CONSERVATION TEAM CONSULTATION APPLICATION RESPONSE

APPLICATION REF:	25/01892/FPH & 25/01893/LBC
CASE OFFICER:	HT
APPLICATION SITE:	190 Park Lane, Old Knebworth, Knebworth, Hertfordshire SG3 6PS
DESCRIPTION OF WORKS:	Replacement of 9 existing timber frame windows with double glazed white flush timber casements.

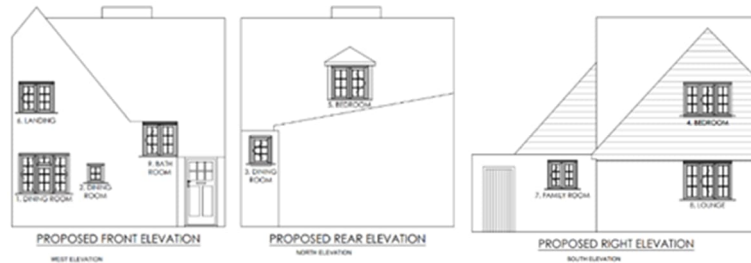
I met with the applicant on site on 1 October to assess the quality of the existing joinery and ironmongery. As noted on the proposed elevations below, there are 3no. 3-light windows, 4no. double-casements, 1no. 6-pane casement and 1no. quarter-pane casement.

In my opinion, all but windows 1 and 7 are original to Lutyens design with extruded sash ovolo type internal glazing bars and black monkey-tail latches. Please note the following:

- I raise no objection to the replacement of windows W1 and W7 (which are later replacements) with well-detailed slimlite windows.
- The design of replacement window 1 could be improved by omitting the top-hung light.
- It would appear that the annotation for windows 6 and 9 on the Proposed Elevation drawing are the wrong way round.
- Window 3 is a 9-pane as shown on the Existing Elevation whilst on the Proposed Rear Elevation it shown as a 6-pane window. I don't think the applicant was intending changing the size of this opening and the 6-pane proposal may be an error.
- There is not a particularly well-justified case for replacing original windows 2, 3, 4, 5, 6 (bathroom not landing), 8 & 9 (landing not bathroom). As I see it, window 2 (quarter-pane to dining), 3 (9-pane to kitchen) and 9 (landing) could readily remain

in-situ and I am unconvinced that double-glazing these windows will significantly impact upon the building's ability to retain heat and should not have a particularly significant impact upon living conditions.

- The question is whether there is a case to replace original windows 4, 5, 6 (bathroom) and 8 to habitable rooms? Subject to an improved detailed-design I may be prepared to look at this further although the applicant has said that the internal shutters to window 8 do have heat-retaining properties.

The proposed windows have what I would regard as industry-standard 28mm wide dgu's and applied or bonded glazing bars with a spacer bar between. In other words, these would not be slimlite glazed windows with 'through' glazing bars. These two aspects of window design would occasion harm to the listed building's special interest.
